LANE AVENUE STUDY

Engagement Summary
January 16, 2020

02
ENGAGEMENT
REVIEW - ROUND 2!

Streetscape - Corridor

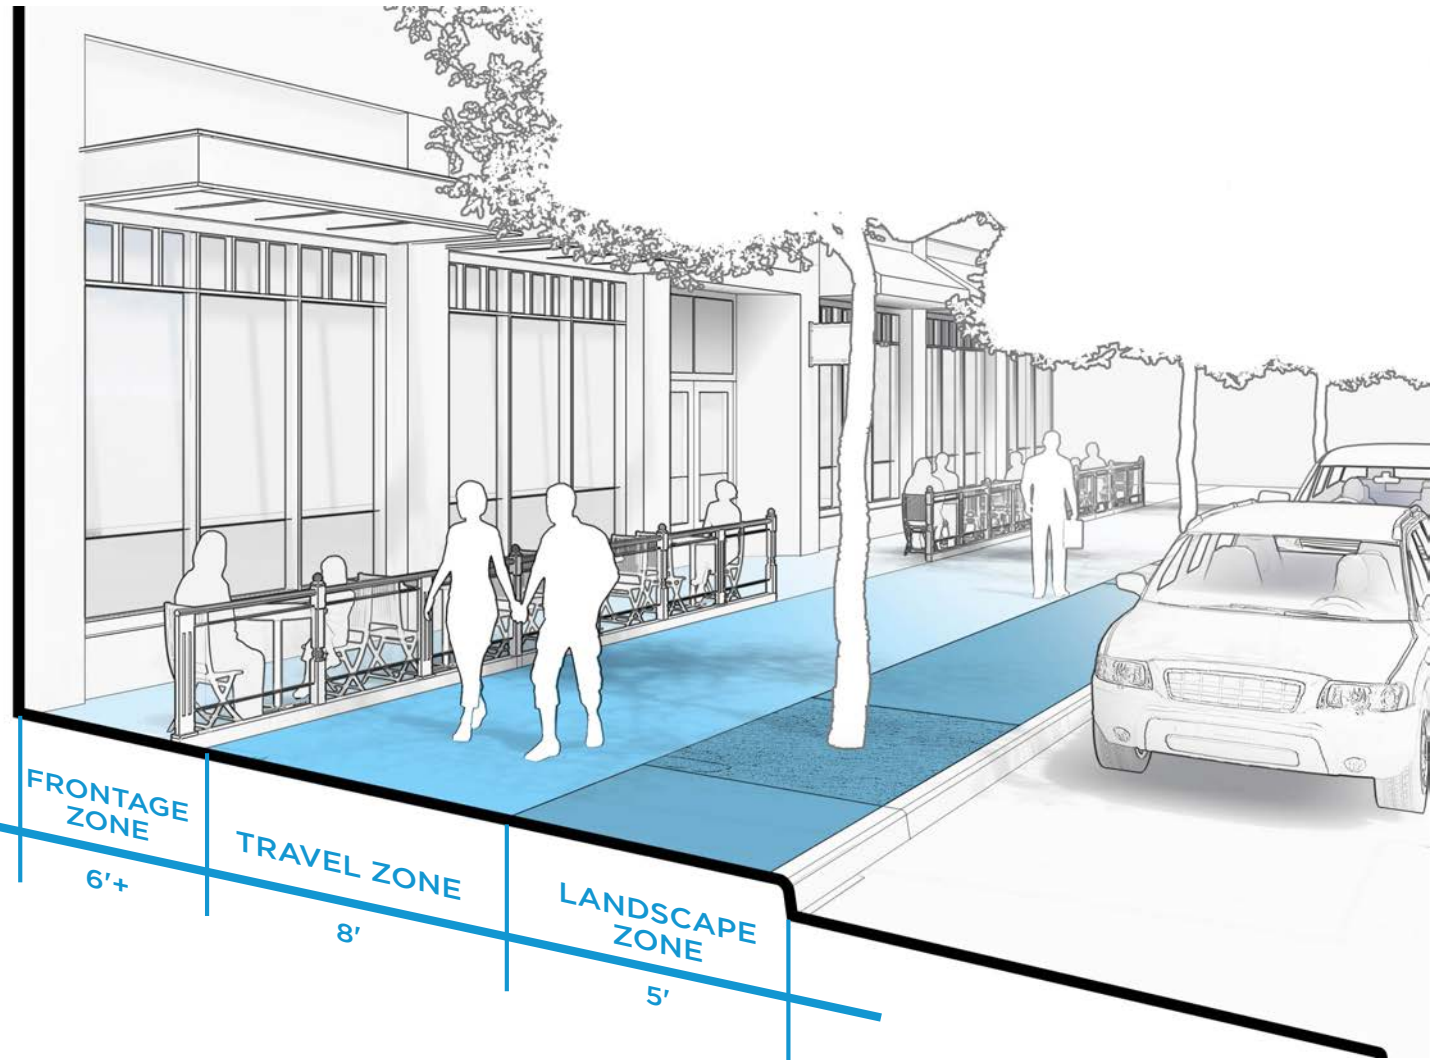
- LOVE the frontage zone for dining
- Very appealing
- Would like more buffer between pedestrians and street to make dining and walking more pleasant and safe
- Especially concerned about room for bicyclists here

Streetscape - West Gateway

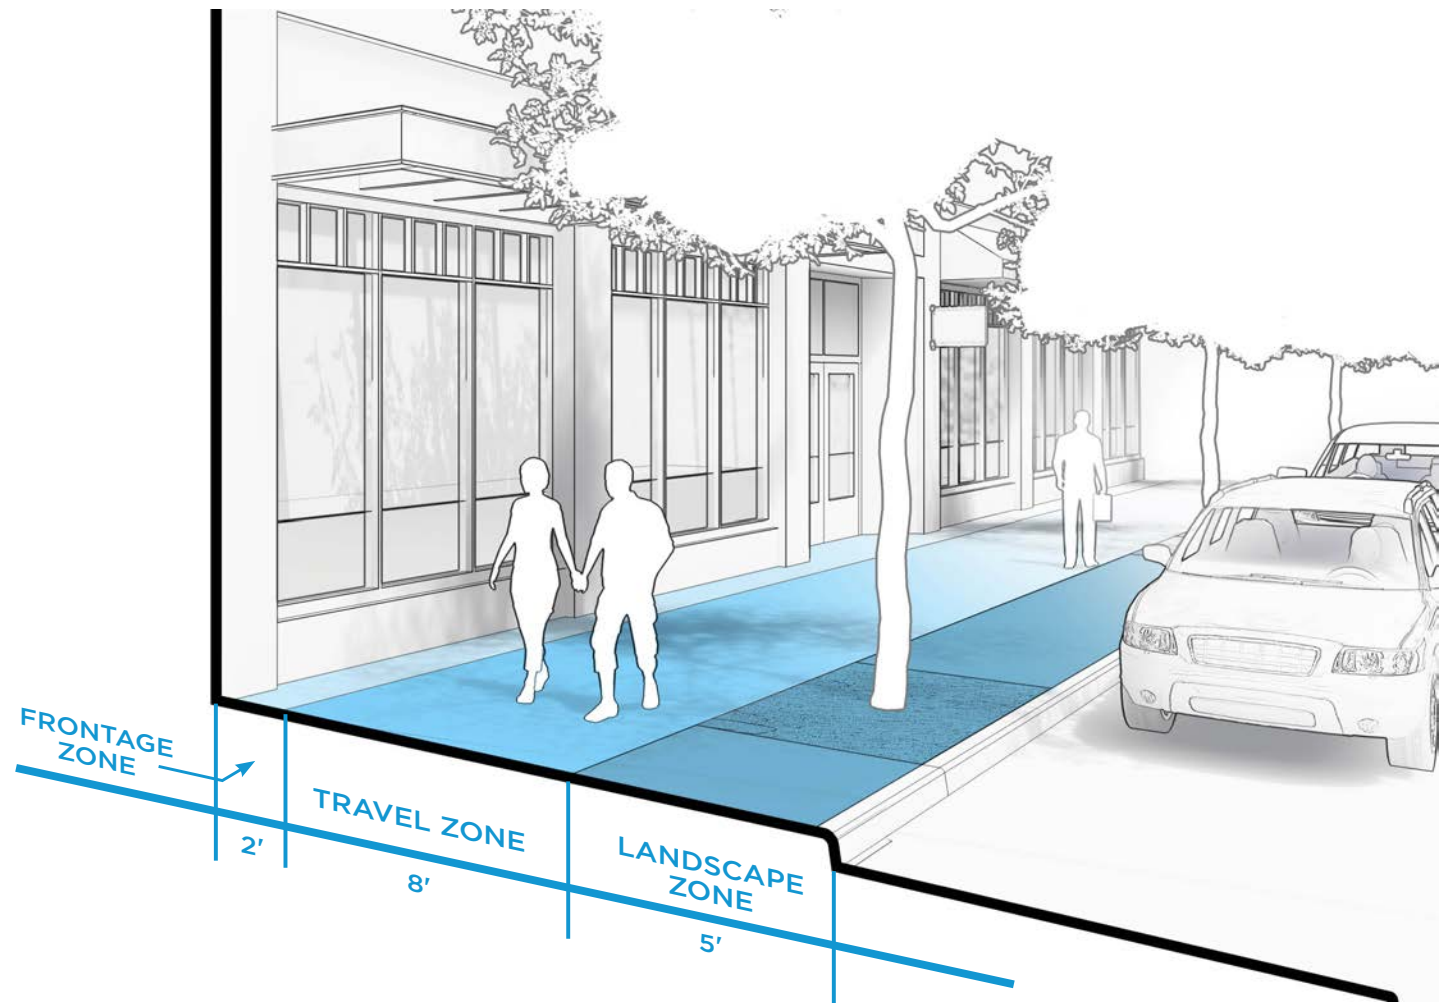
- Less aesthetically pleasing
- Plain and simple
- Prefer other options that allow for space for outdoor seating. Landscaping area not sufficient.
- Mixed appreciation of natural landscaping VS boxed planters
- Thoughtful connection to East and nearby residences

Streetscape - Neighborhood

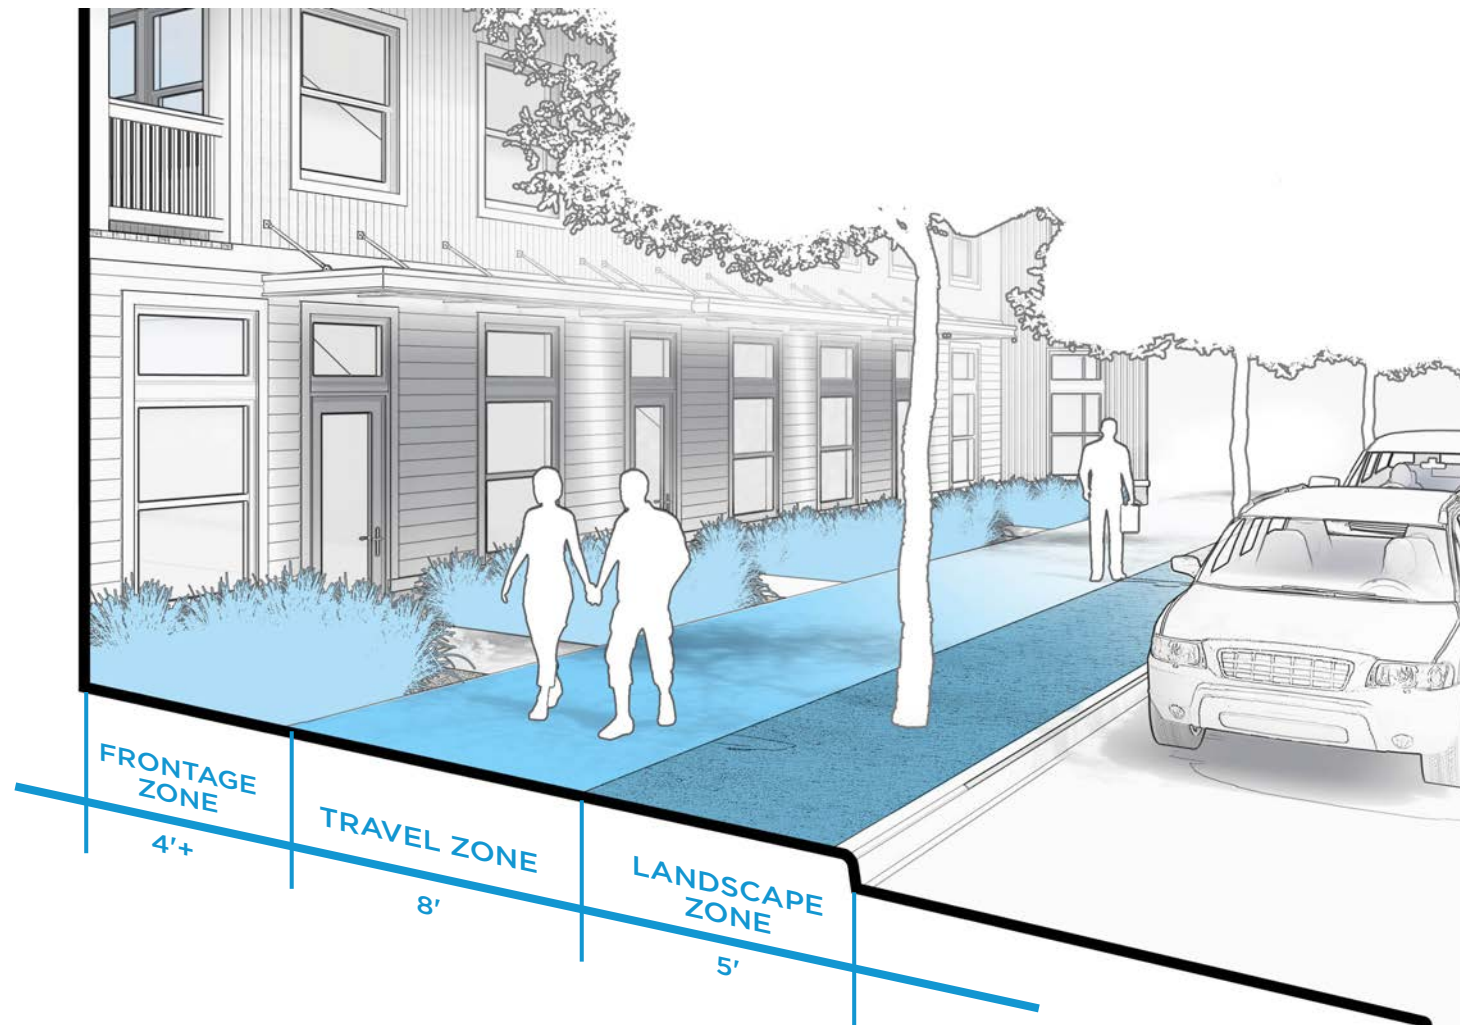
- Big improvement over current
- Supports residential feel and transition into neighborhood
- Concern there is no space for outdoor seating or dining
- Concern for how close the homes are to the road (safety/noise)
- Concern for maintenance of turf falling on private owners
